NOV_SCE_EDC_ 20211116-01

NOTICE OF VIOLATION

Energy Safety Inspection Report

Report Name: SCE_EDC_20211116-01

Structure ID: 1922869E

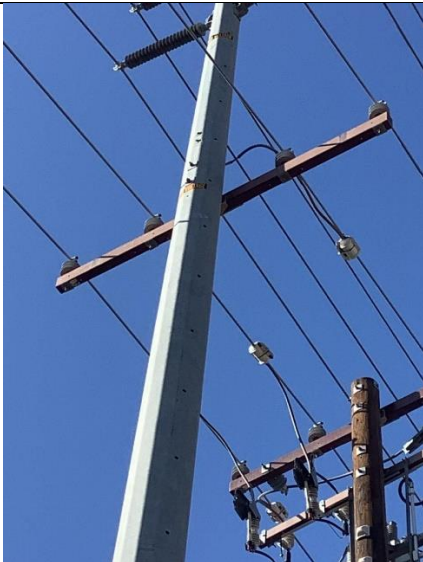
Item3IA1Img1: No vibration dampers installed

Structure ID: 4477212E

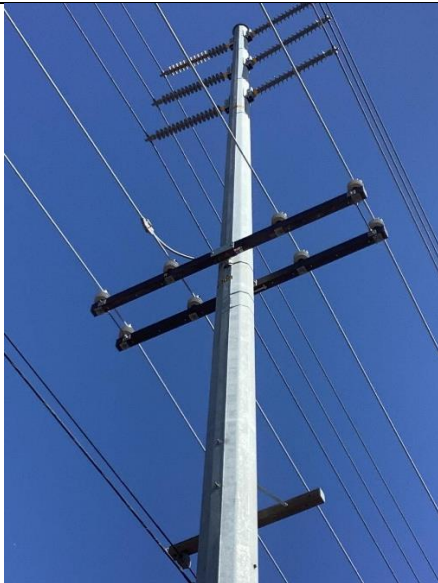
Item7IA1Img1: Vibration dampers not installed

Structure ID: 1922664E

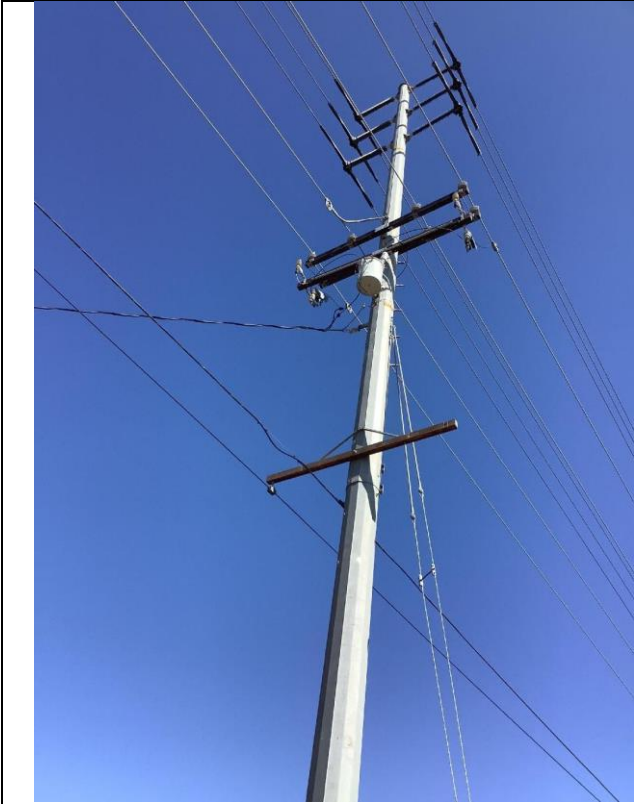
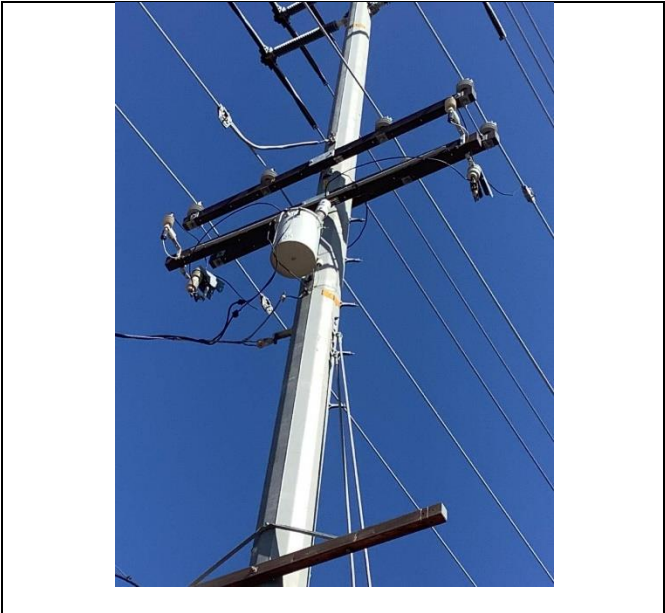
Item9IA1Img1: No vibration dampers installed

Structure ID: 447723E

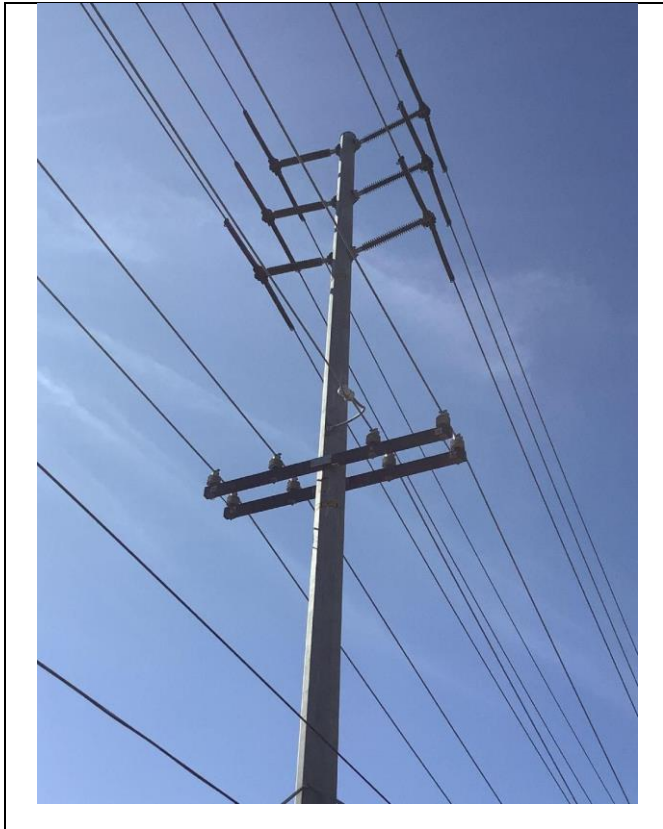
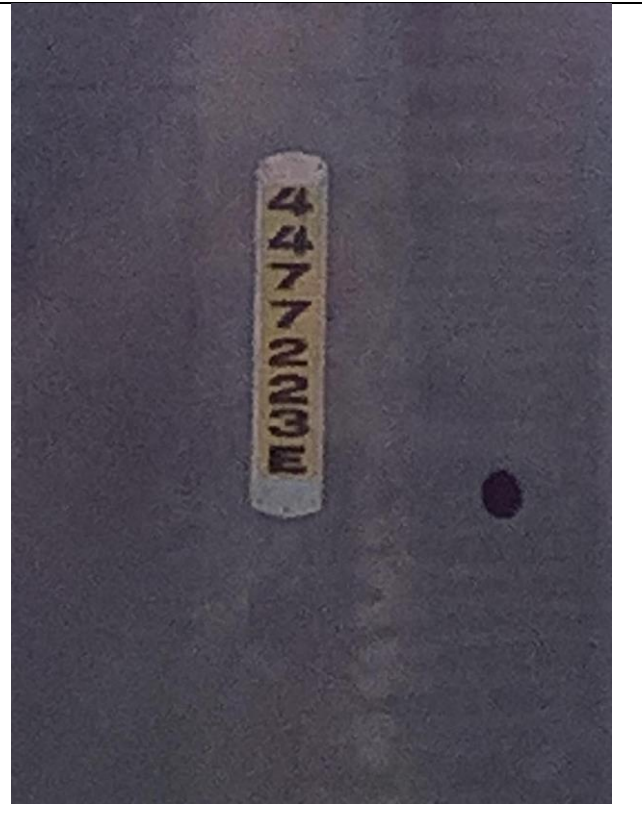
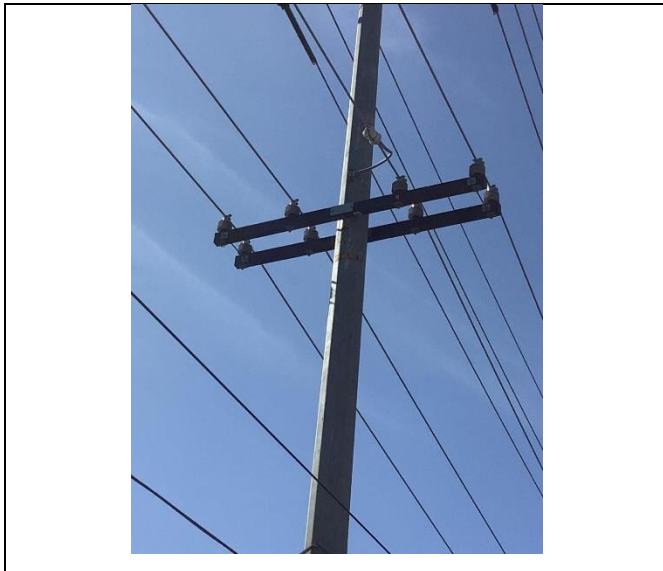
Item10IA1Img1: No vibration dampers installed
